**Revised Exhibits F-M**  
**Planning Commission September 26, 2013**

# ARCO AM/PM - ELDORADO HILLS, CALIFORNIA

**Subject: Response to noise-related public comments on the Green Valley Convenience Center project.**

**C2.0 OF 6**

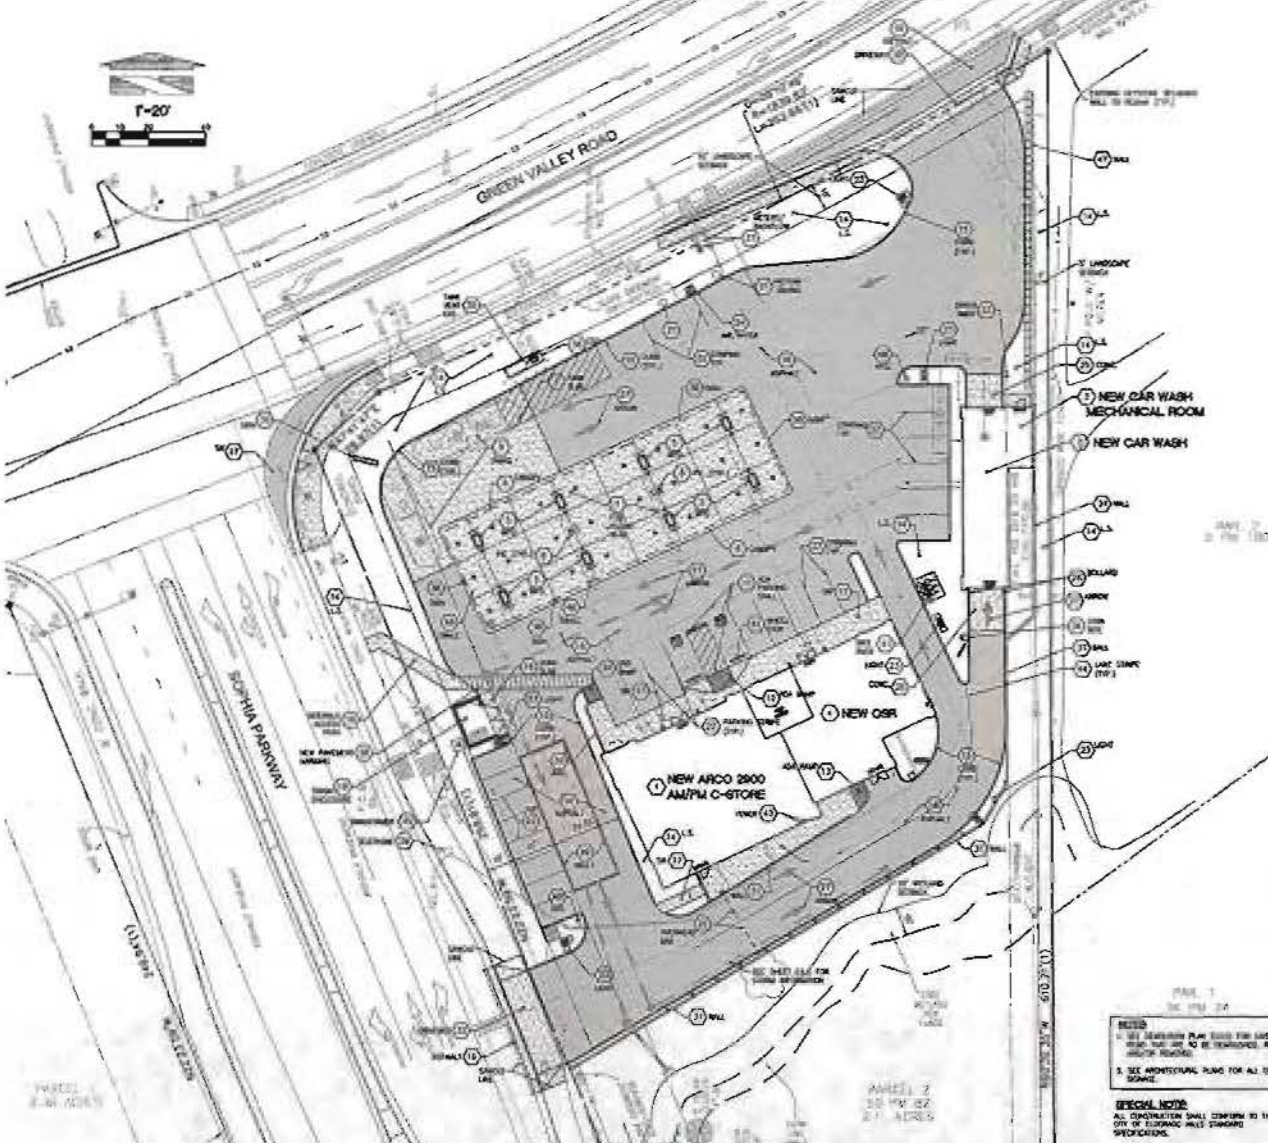
The issue of encroachment into and out from the site from and onto Green Valley Road is a concern to the public. The latest alternative encroachment design, shown on Sheet C2.0 dated August 29, 2013, provides for a longer taper for the encroachment but is not a full acceleration/deceleration lane as suggested by some members of the public. Technically, this requires a Design Waiver request since it is a deviation from the Standard Plan for commercial encroachments onto an arterial road. Transportation Division staff finds the modified design to be acceptable, and provides somewhat greater turning ability into the development. Findings for Approval of the Design Waiver are included in the Revised Attachment 2. Additionally, the Transportation Division is recommending that Condition 23 be revised as follows:

23. **Encroachment Permit:** The applicant shall obtain an encroachment permit from ~~DOT~~ Transportation and shall construct the roadway encroachments from the access roadway onto Green Valley Road and Sophia Parkway to the ~~provisions of~~ County Design Standard 110 as shown on Sheet C2.0 – Site Plan dated August 29, 2013, and the change shall be reflected on the development plans submitted for the project. The improvements shall be completed to the satisfaction of the Transportation Division or the applicant shall obtain an approved improvement agreement with security, prior to the issuance of an encroachment building permit.

Accident data shall be collected and the operation of the driveway along Green Valley Road shall be observed periodically for a span of one year from the date of occupancy. The EDC Transportation Operations Unit will identify accidents related to the turning movements into or out-of the project encroachments and determine if a statistically significant increase in accidents has occurred. If Transportation quantifies information indicating the driveway is not functioning appropriately they will notify the owner of their observations in writing and request the owner propose an action plan to bring the driveway to proper function within 30 days. The criteria and measures needed to return the driveway to proper function shall be mutually agreed to by the applicant and the County and will be implemented within 90 days of agreement. If agreement cannot be reached the matter will be brought before the Planning Commission as an amendment to the Development Plan for resolution which will be deemed final unless appealed to the Board of Supervisors.

**Figure 1**  
 ARCO AM/PM at Green Valley Road and Sophia Parkway - El Dorado Hills, California  
 Project Area, Ambient Noise Measurement Location and Noise-Sensitive Receiver Locations

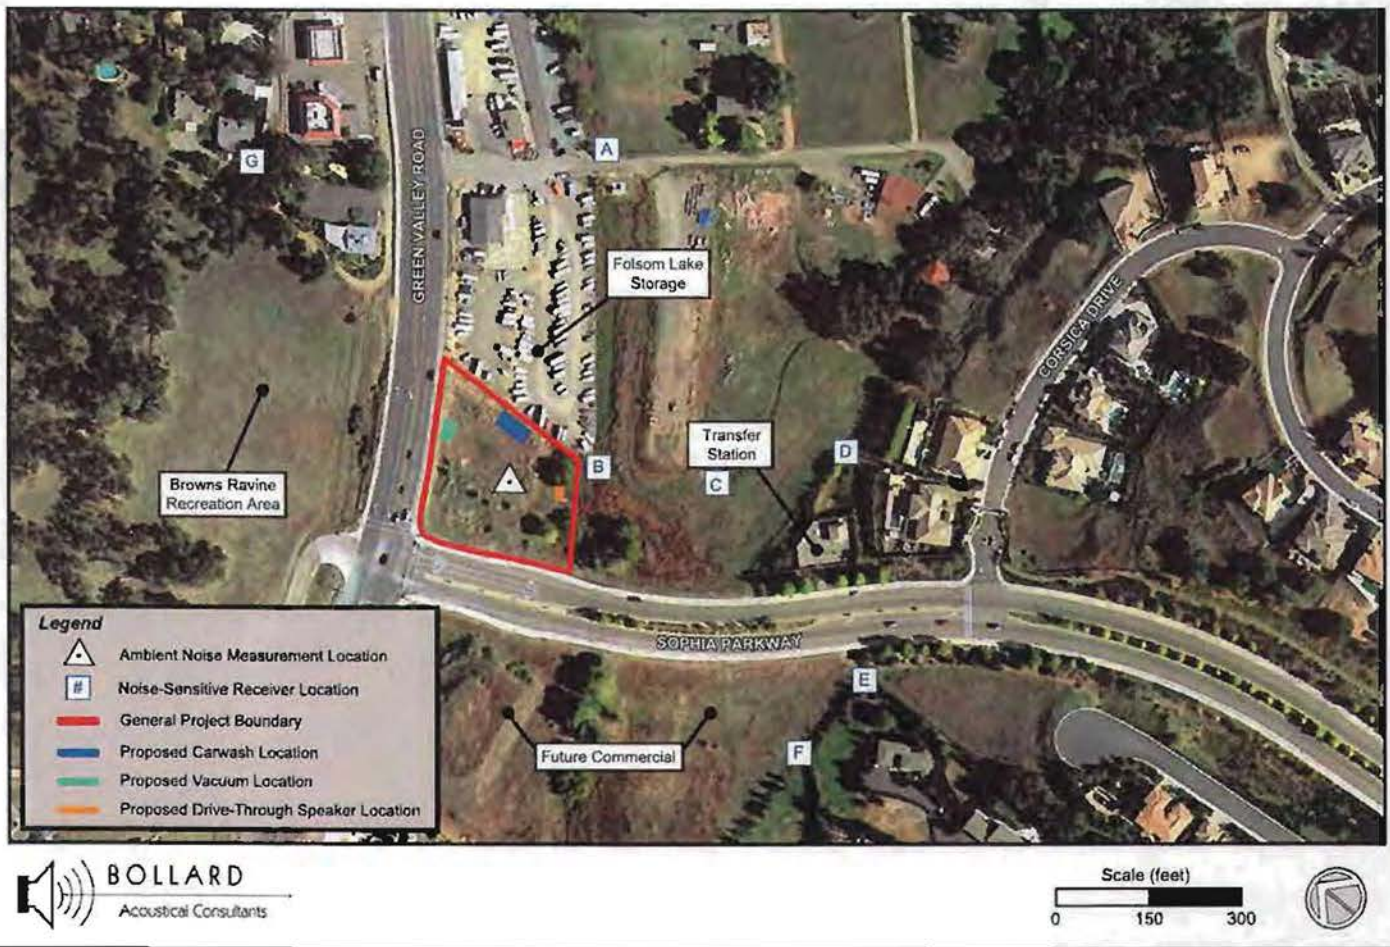
**Comment 1c:** The Initial Study identifies that measurements of noise exposure must be taken at “the adjoining property line of a noise sensitive land use”. However, the Environmental Noise Analysis (see Figure 1) does not do this and places the measurement locations in rear yards or at the residential structure – or rather, in places it is determined by the analyst to be the “nearest noise-sensitive receiver”. This is not consistent with the directives of the General Plan, Table 6-2, bullet No. 3, which states, in part, “In Community areas the exterior noise level standard shall be applied to the property line of the receiving property”. The nearest residential property line (zoned R2A) is approximately 30-50 feet away from the proposed car wash facility on the subject site. It may be even closer!

**Response:** This comment is noted. In the revised acoustical study dated September 25, 2013, noise impacts were analyzed at the property lines of the nearby properties, rather than in the rear yards. It should be noted, however, that bullet #3 goes beyond the quote provided by DAS. The next sentence of bullet #3 states, “*The above standards shall be measured only on property containing a noise sensitive land use as defined in Objective 6.5.1.*”
